DDP / RFP 100025200

Employment and
Social Development Canada

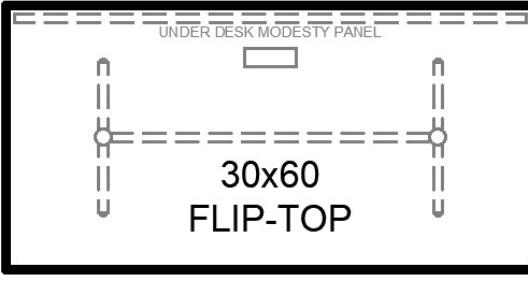
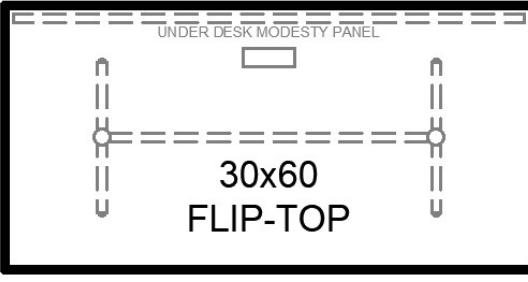
FRANÇAIS	ENGLISH
<p>QUESTION #1</p> <p>Ces tables doivent-elles être équipées d'un système d'alimentation modulaire ?</p> <p>Dans l'affirmative, veuillez fournir la disposition principale des tables, ainsi que des dessins électriques indiquant le nombre de circuits disponibles et leur emplacement. Ceci est nécessaire pour que nous puissions inclure la quantité et la taille appropriées de cordons de démarrage, de harnais et de connecteurs.</p>	<p>QUESTION #1</p> <p>Are these tables required to have a connecting modular power system?</p> <p>If yes, please provide the primary layout for the tables, and include electrical drawings with the number of circuits available and their locations. This is required so that we may include the appropriate quantity and size of starting-cords, harnesses, and connectors.</p>
<p>RÉPONSE #1</p> <p>Oui, les tables nécessitent un système d'alimentation modulaire. Chaque table doit avoir deux prises de courant et deux ports USB situés au centre supérieur de la table. Vous trouverez ci-dessous la disposition principale de chaque table, ainsi qu'une photo exemplaire de ce que la table nécessite.</p>  <p>The diagram shows a rectangular table top labeled "30x60 FLIP-TOP". At the top center, there is a rectangular cutout labeled "UNDER DESK MODESTY PANEL". On either side of this panel, there are two power outlets (two vertical lines with circles) and two USB ports (two vertical lines with squares). The entire diagram is enclosed in a black border.</p>	<p>ANSWER #1</p> <p>Yes, the tables do require a connecting modular power system. Each table should have two power outlets, and two USB ports located in the top center of the table. Below you will find the primary layout of each table, as well as an example photo of what the table requires.</p>  <p>The diagram shows a rectangular table top labeled "30x60 FLIP-TOP". At the top center, there is a rectangular cutout labeled "UNDER DESK MODESTY PANEL". On either side of this panel, there are two power outlets (two vertical lines with circles) and two USB ports (two vertical lines with squares). The entire diagram is enclosed in a black border.</p>
